GEM TN-92-143

Calorimeter Group Meeting - SSCL

Responses to Questions
Regarding Engineering Issues
of the
GEM Nobel Liquid Calorimetry Options

5 August, 1992

Figure 3-2 End View of Liquid Argon Calorimeter Showing Stanchion Locations

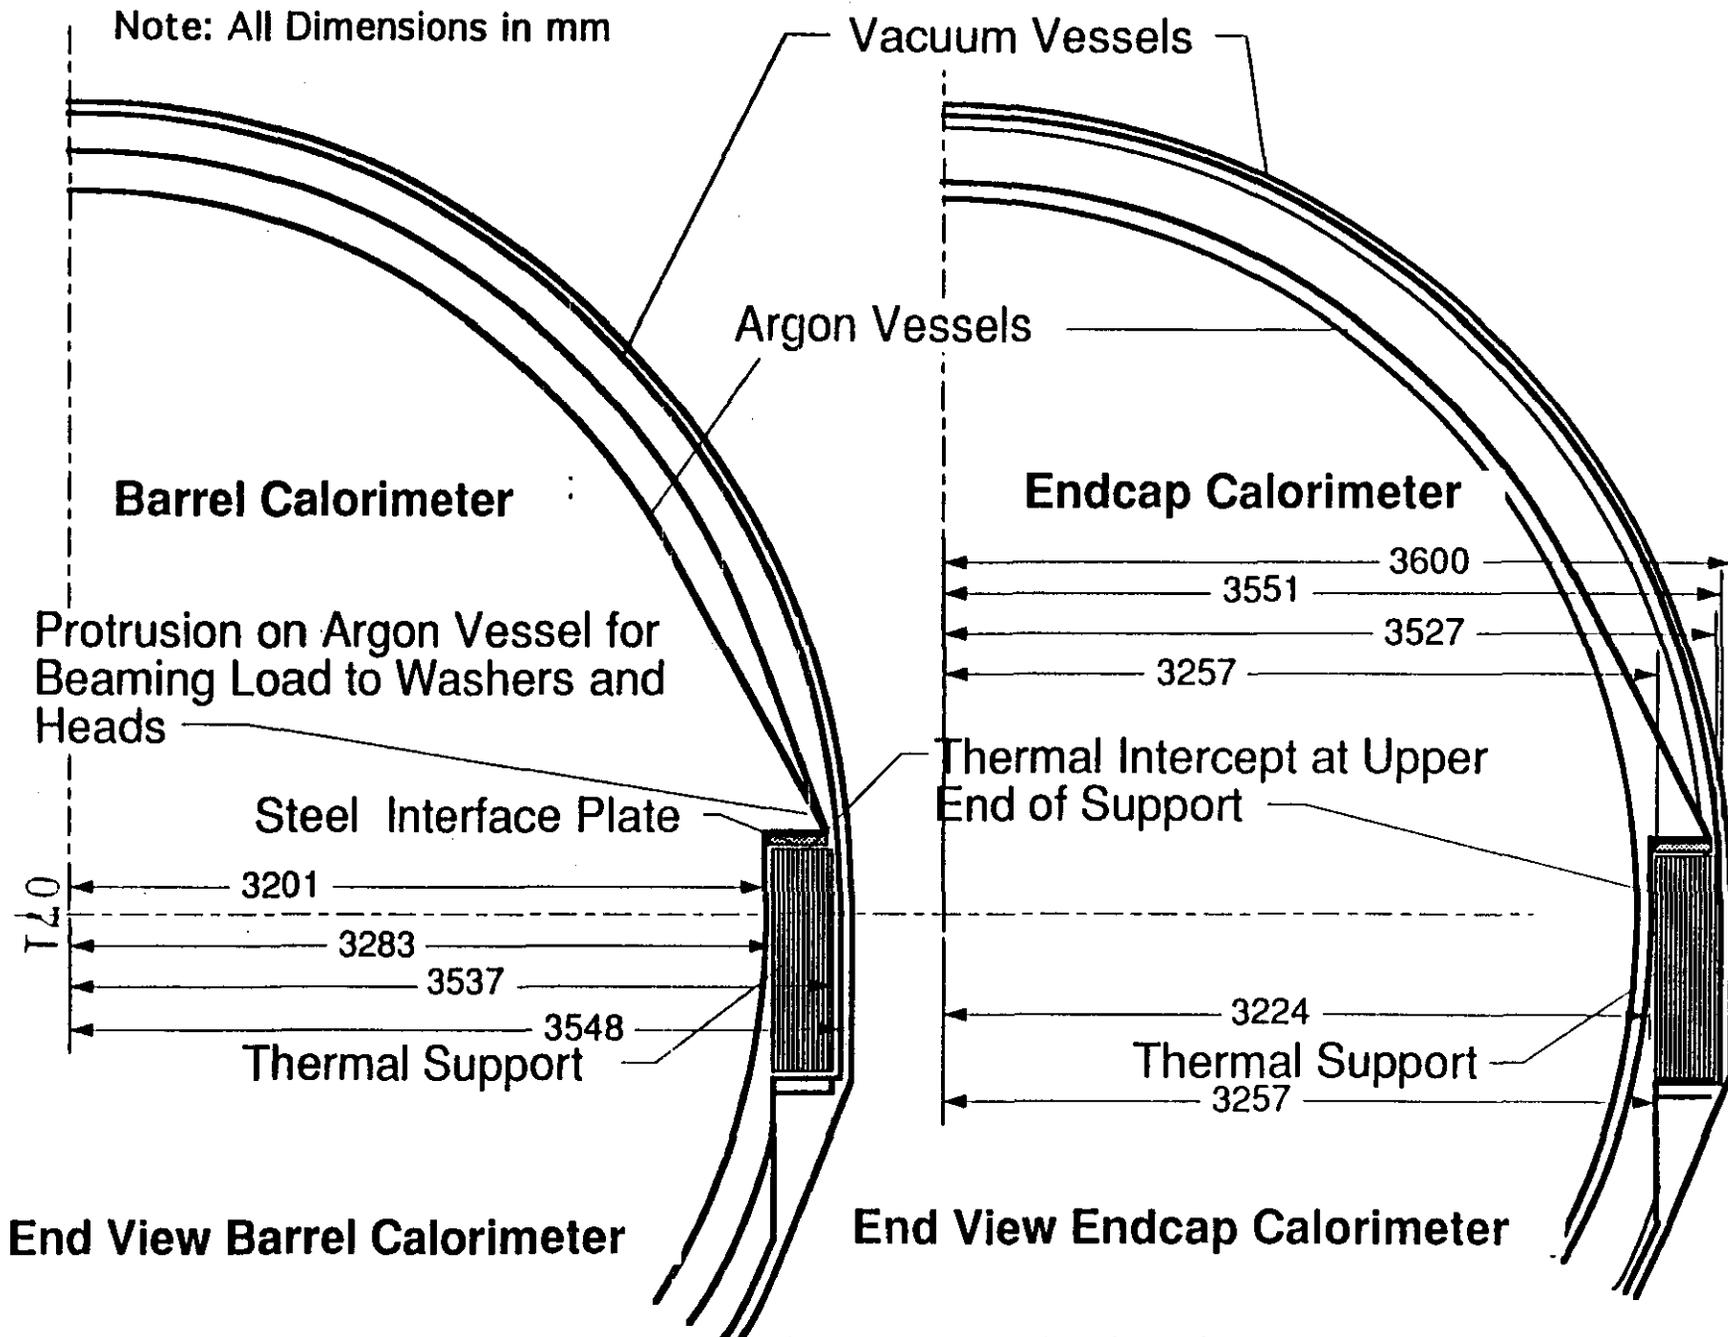
Request: Provide a scaled end section view of the liquid argon vessel cold mass supports.

- Plan and end views of the liquid argon vessel showing the locations of the stanchions (cold mass supports) are given in Figures 3-1 & 3-2, respectively.

Figure 5-3 Cooling Tube Hadron Module Stay Concept

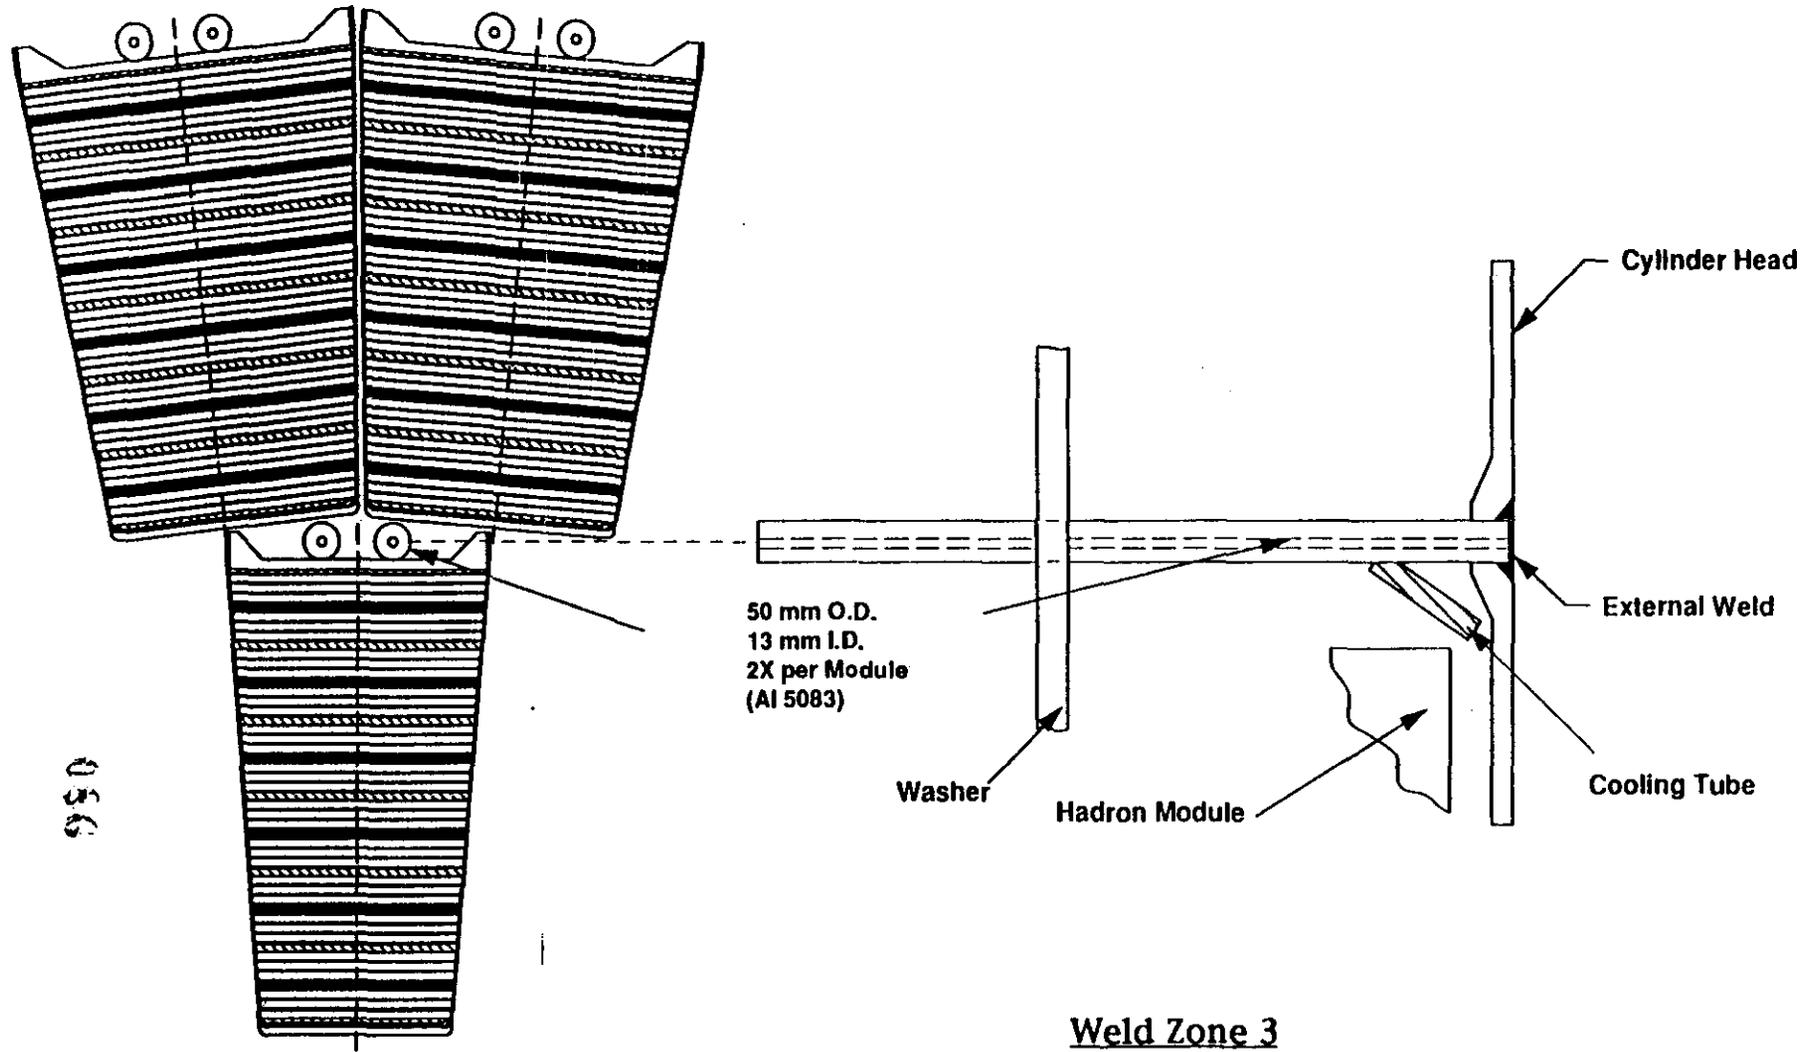
- Sealing the liquid argon vessel after the installation of the EM assembly involves significant risk due to proximity of the welds to the cables. However, by using shields in the vicinity of the weld joints and by using bolted connections this risk can be minimized (reference Figures 5-4 & 5-5).

- Instead of using solid plates as stays better options exist. One such option would be to replace the solid plate stay with two tubes (reference Figure 5-3). The tubes would serve a dual role by acting as a stay and providing an active cooling tube for cooling the preamps during operational usage. The welding and overall assembly is easier and less heat input is required for the necessary partial penetration weld. This concept also eliminates the need for a backing bar since a full penetration weld is no longer required. The final weld is made on the outside and the overall heat input and cable shielding concerns are less.
